Safety Recall 26S52 - Supplement #1

Certain 2020-2027 Model Year Aviator and 2020-2026 Explorer Vehicles with Power Second-Row Seat – Second-Row Seat Easy Entry Switch Housing and Bezel Replacement

New! REASON FOR THIS SUPPLEMENT

FIGURE 1

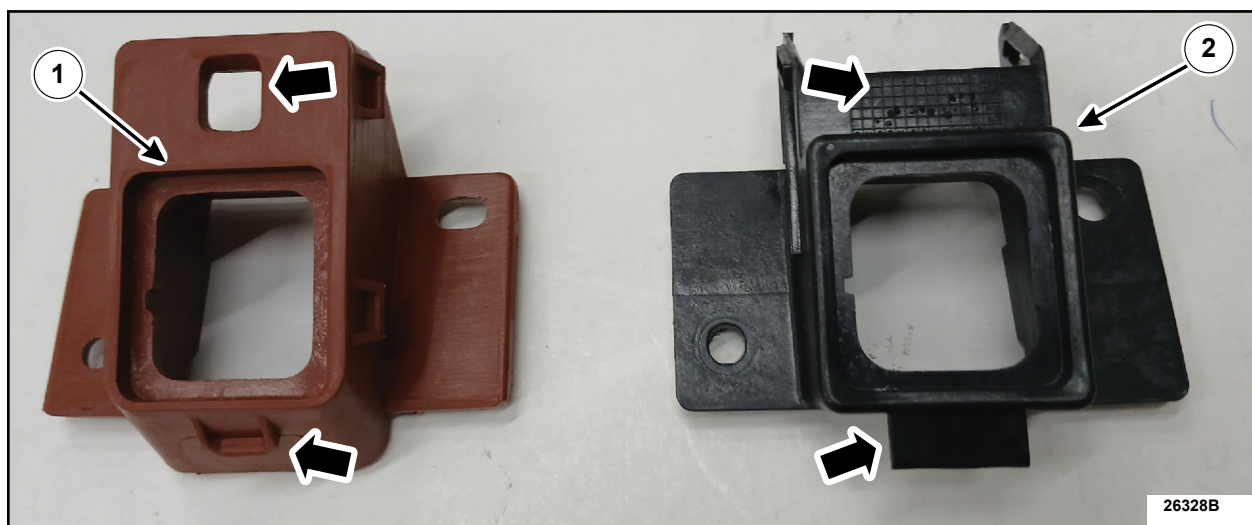
NOTE: The *new* components (1) are physically different than the original components (2) being removed in this procedure. See Figures 1 and 2 for the differences.
